SERVICE BULLETIN

PURPOSE : Addition	ISSUE NO. : MSB-15E42-007	DATE : 2015-12-21
SUBJECT : Addition of the service points regarding the disassembly and reassembly of the keyless entry transmitter for the vehicles for Israel		<DESTINATION/MODEL> (Israel) <M/Y> 16
GROUP : Gr:42(Body)		LANCER(CY0A)/LANCER SPORTBACK(CX0A)

Attached sheet 1 (1/2)

DISASSEMBLY AND REASSEMBLY <Vehicles for Israel>

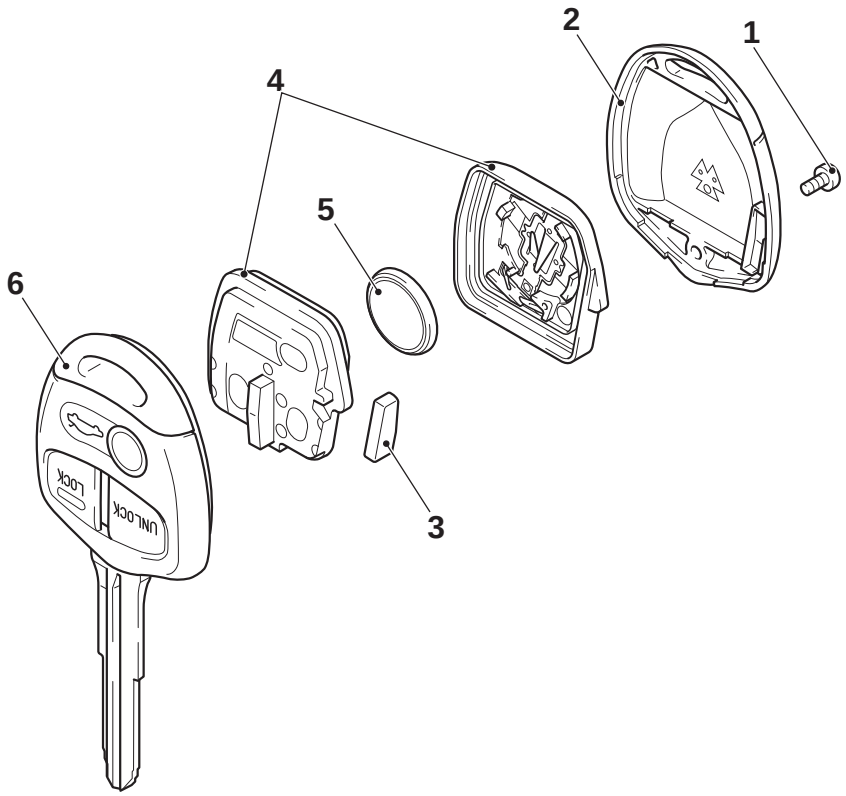
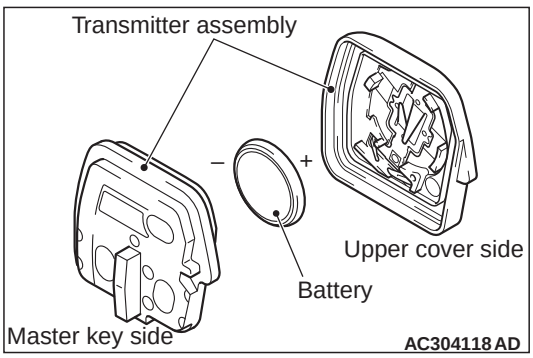
<Added>

When disassembling the transmitter, static electricity may damage the internal electronic circuit. Therefore, be sure to release static electricity from your body before disassembling the transmitter.

Install a new battery, with (+) side facing the upper cover of the transmitter assembly.

Battery required for replacement: Lithium battery CR1616
